YESLER TERRACE BLOCK 5 | BLDG A

EAST DESIGN REVIEW BOARD

DESIGN RECOMMENDATION MEETING #2

209 12TH AVE S | PROJECT #3026743

REC 2 REVISED MASSING

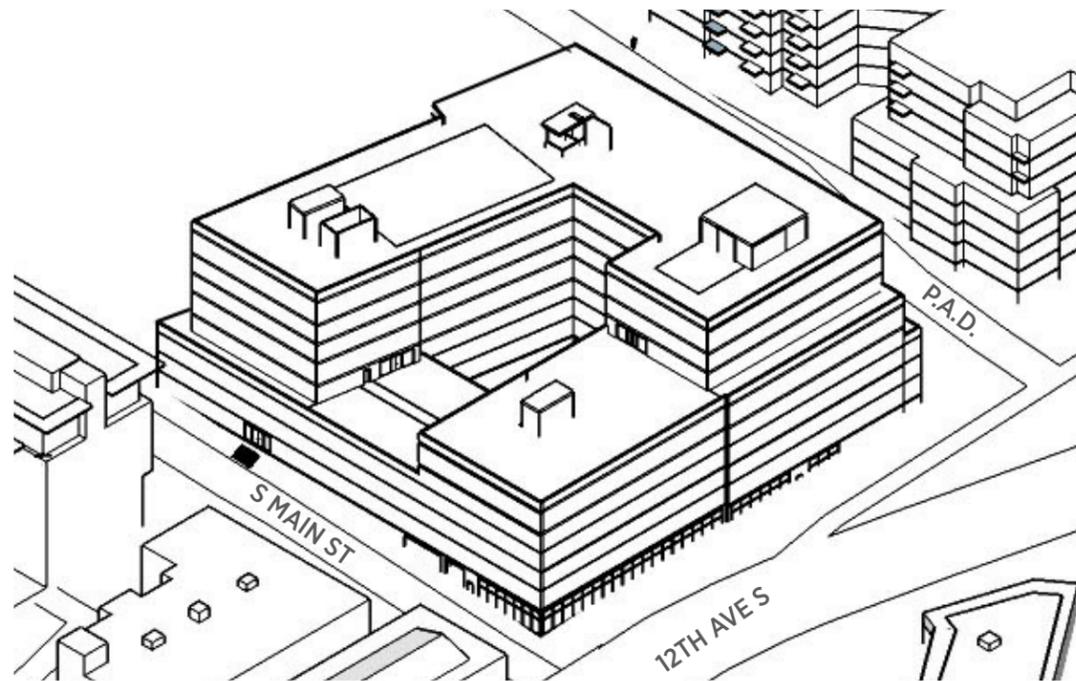
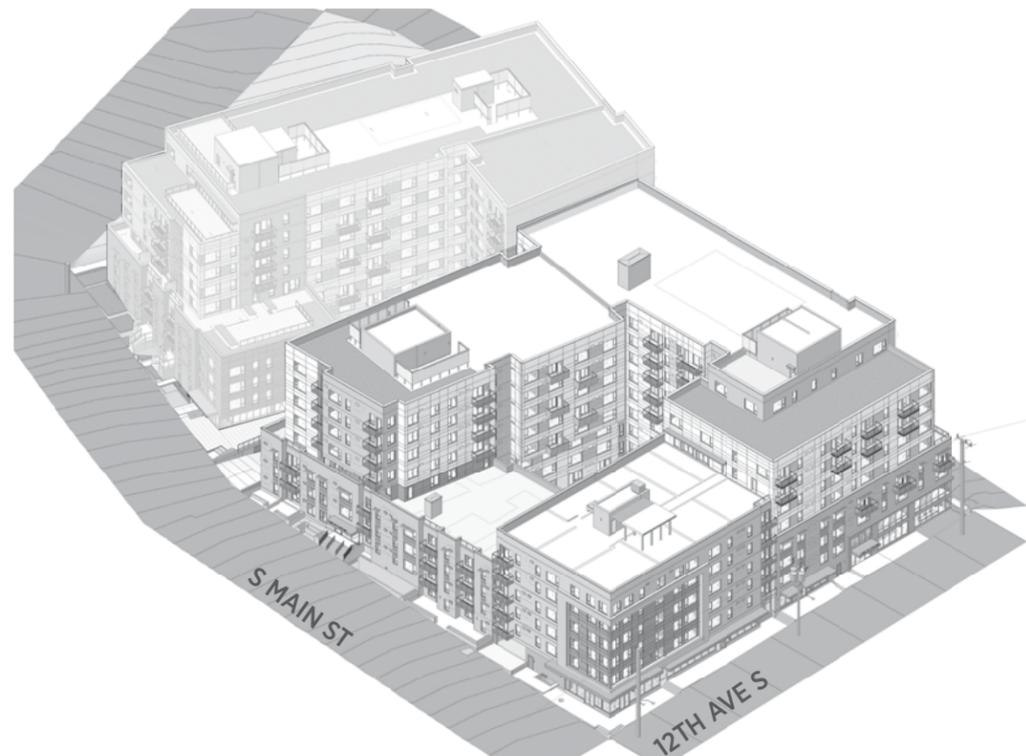
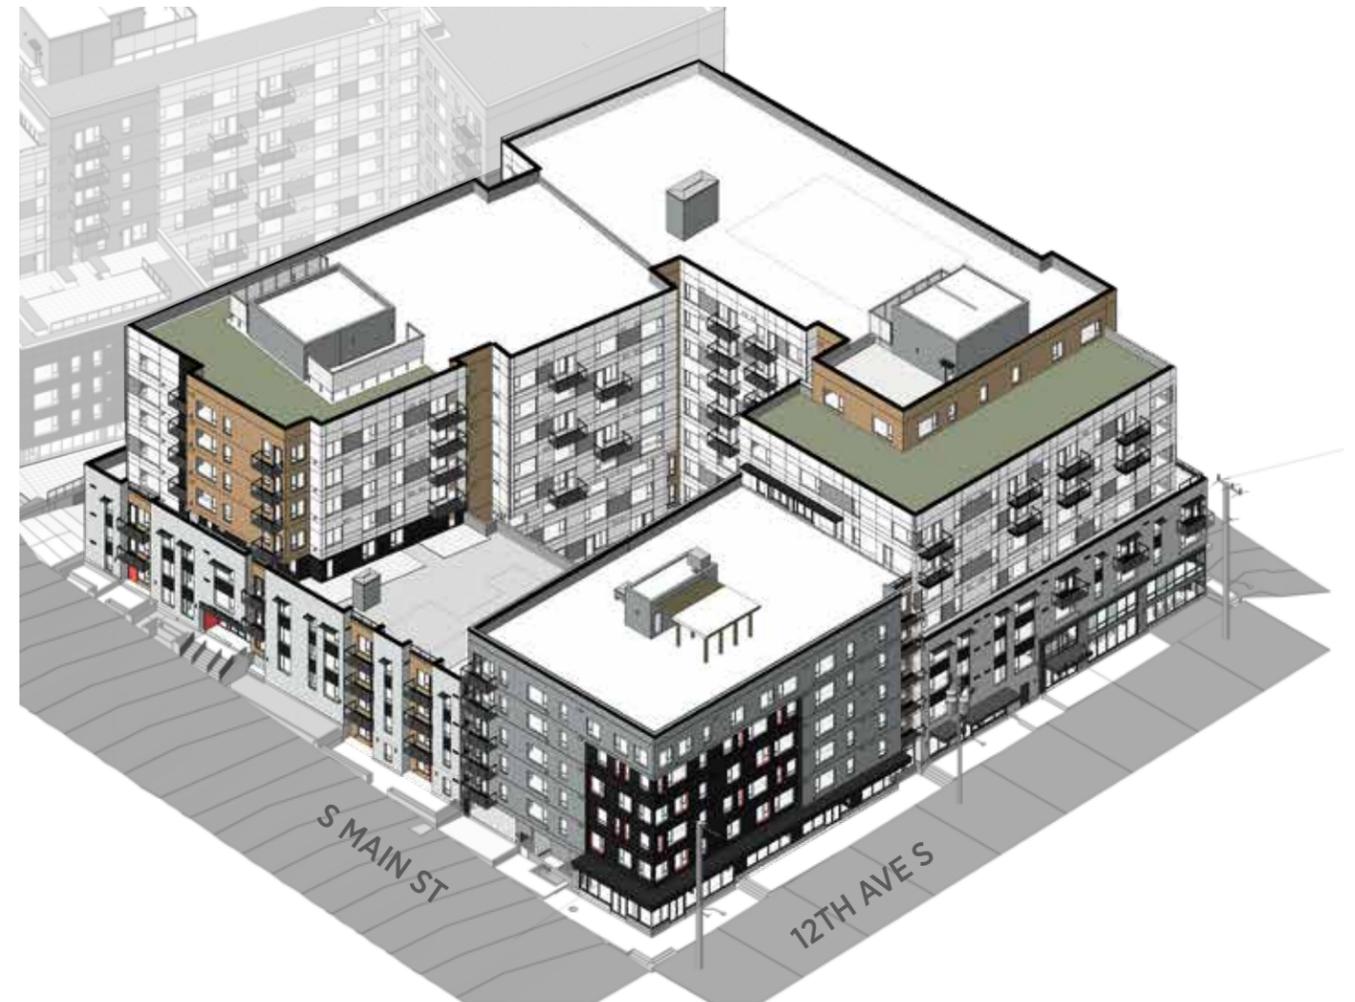
REC 1 meeting for Building A: (1.) The Board agreed that the design development is generally heading in the right direction and strongly supported the refined massing at the northeast corner, which was lowered from nine to eight levels. For the massing along 12th, the Board recommended increasing the upper setback closer to the 5' previously shown at Early Design Guidance Meeting while retaining the lowered massing at the Northwest corner. The Board indicated that increasing the setback from 1' to 3' may be acceptable to create a legible setback.

At EDG the 5' setback was located at Level 6. At REC 1 the setback was dropped to level 5 for better 12th Ave facade proportions and level 9 was pushed back 28'. We were able to achieve a 2'-6" setback at level 5, a perfect amount to create a heavy depth and cornice. A 3'-0" setback was studied but created unsuccessful units along that facade.

6 REC 2 - WOOD FRAME REMOVED, POP-IN DEPTH INCREASED, POP-IN MASSING EXTENDED HORIZONTALLY ALONG RETAIL

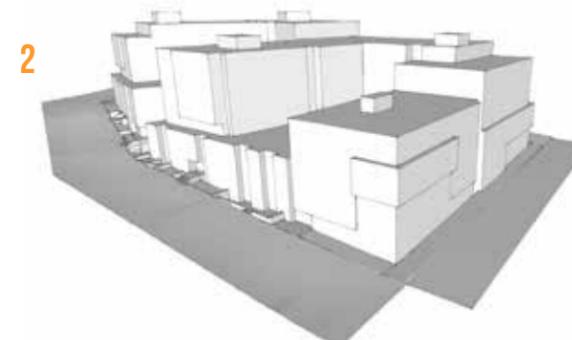
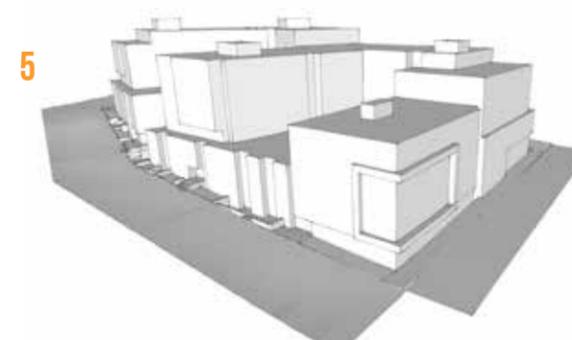
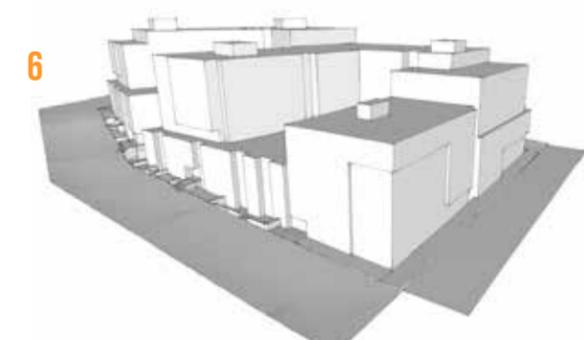
REC 1 meeting for Building A: (2.a) To signify the prominent corner, the Board recommended resolving the detailing and reducing the number of different materials proposed at this location. Of the alternates shown, the Board preferred the Southeast corner option referred to as option 3 on pgs. 14-15 of the initial recommendation packet.

2.c. The Board was concerned that the current design of the corner does not reflect the prominence of the site. While the Board noted that the corner parcel is outside of the Yesler Terrace Master Planned Community site, the Board agreed this corner will read as a gateway to Yesler Terrace. To strengthen the materiality of the corner and reflect the prominence of the perceived gateway, the Board agreed that the corner should meet the intent of the Design Guidelines and encouraged studying brick or other high quality materials for the upper corner volume.

The wood frame has been removed and the entire inset has been pushed in from the facade 1'-6". The window patterning at the interior of the inset has been changed to provide focus on that corner. A variety of window frames have been inset with the inset and surrounded with a red/orange metal frame. This metal frame projects 2" past the metal composite panel.

In the studies of the upper massing at the SE Corner, a number of frame and pop-out options were studied. Brick is not appropriate for this corner as the entire lower level is transparent storefront, and floating brick over glass is not using the material in an honest approach.

The SE corner materials are made up of a clean shiplap siding, black metal composite panels at the inset and custom color metal window surrounds.

WALL PENETRATION DETAIL

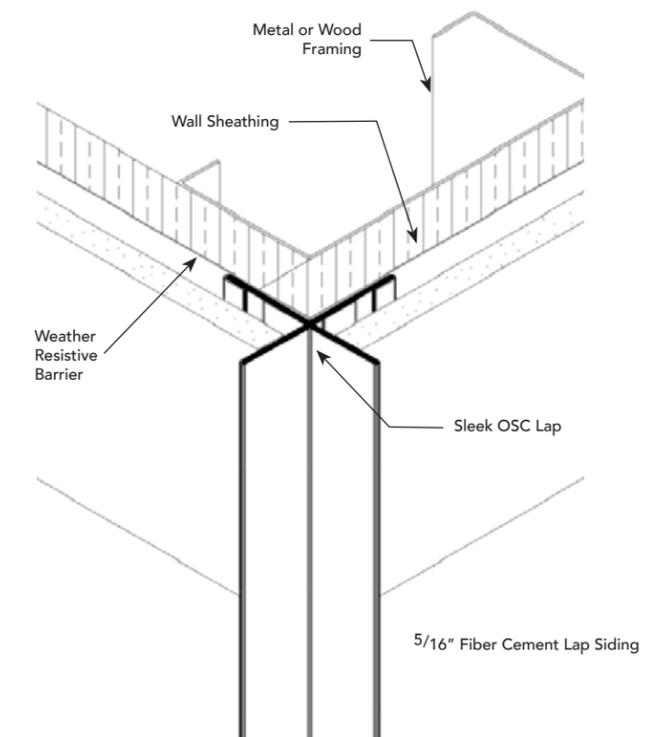
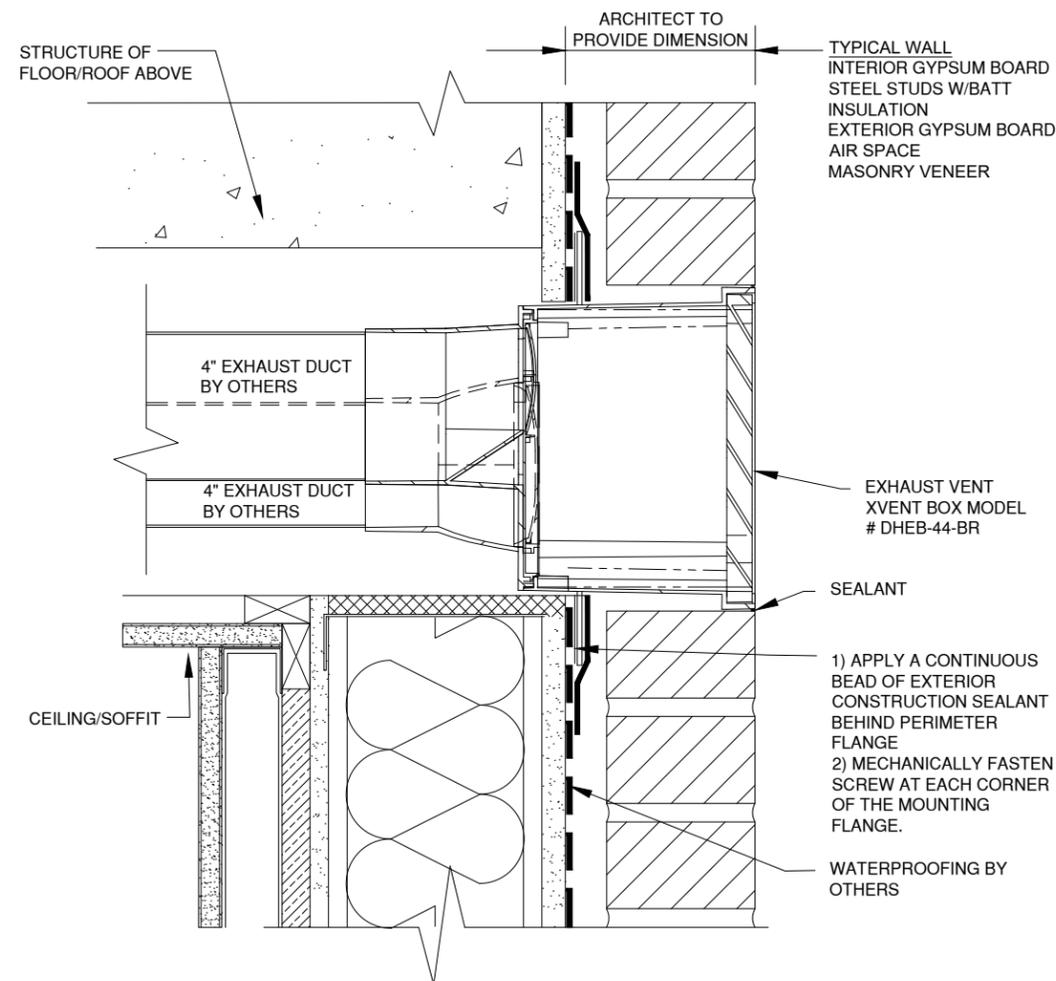
REC 1 meeting for Building A: (2.d.) Related to the facade composition, the Board supported the proposed secondary elements and agreed that the detailing of the vents will also be important. The Board recommended integrating vents in the cladding composition and to show the vent locations in the elevations for the next meeting.

An effort has been made to move all possible vents off the front facing brick facades. The vents used in the brick will be high-quality flush Xvents. These are reflected in the renderings and as shown in the precedent images.

REC 2 ADDED ACCESS DRIVE ENTRIES - 7 STOOPS

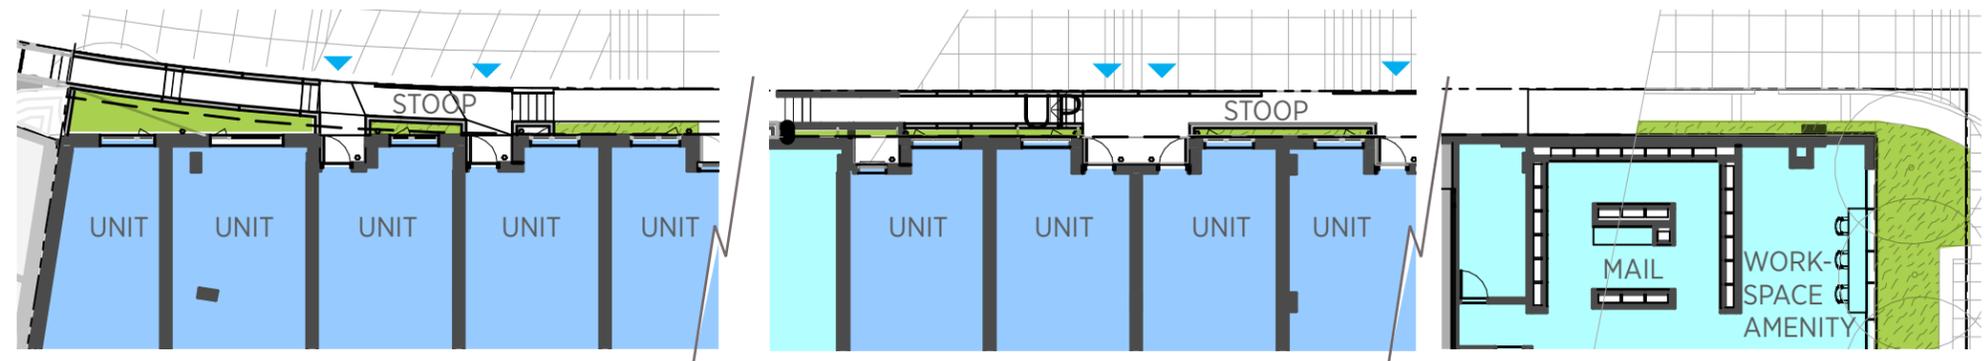
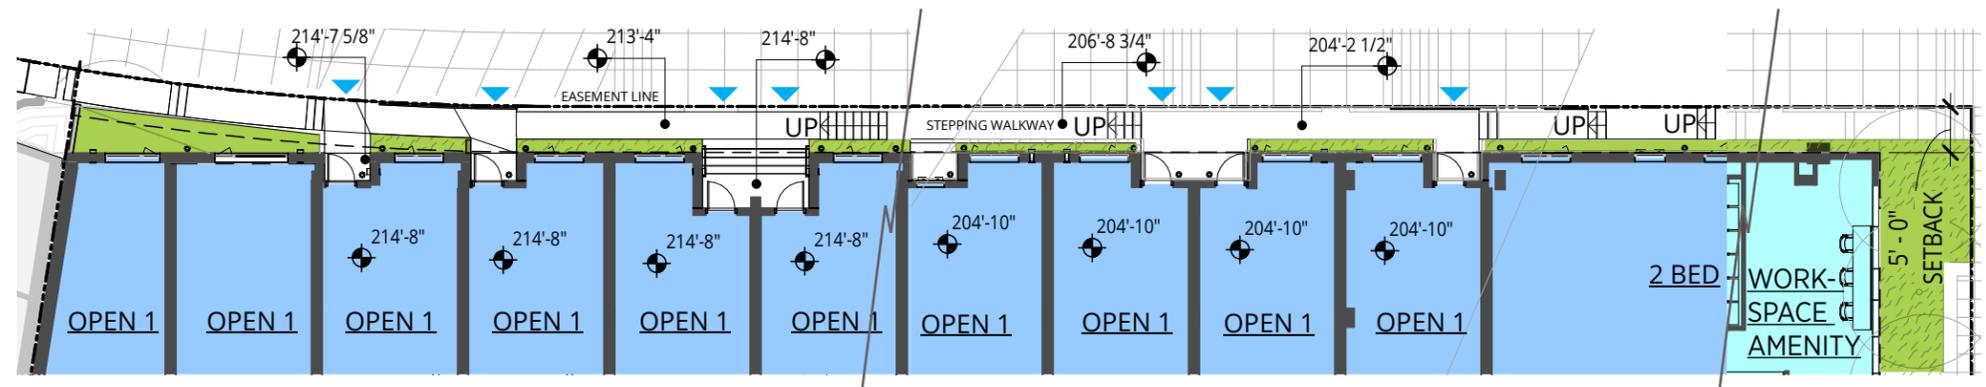
REC 1 meeting for Building A: (3.c.) For the access drive frontage, the Board strongly supported the direct entries and shared circulation space, referred to as the 'stoop walk.' To better meet the intent of the access drive to function as a woonerf, the Board recommended maximizing the number of ground-related residential entries. For the next meeting, the Board requested a more detailed representation of the frontage, individual entries and access drive design, including information on the pedestrian amenities/site furnishings proposed.

In response to the Board Guidance from REC1 we have elevated the stoop walk above the access drive to accommodate 2 additional unit entries. Building A now has 7 units with access from the stoop walk. This change in elevation now requires a guardrail due to the increased height above the drive surface.
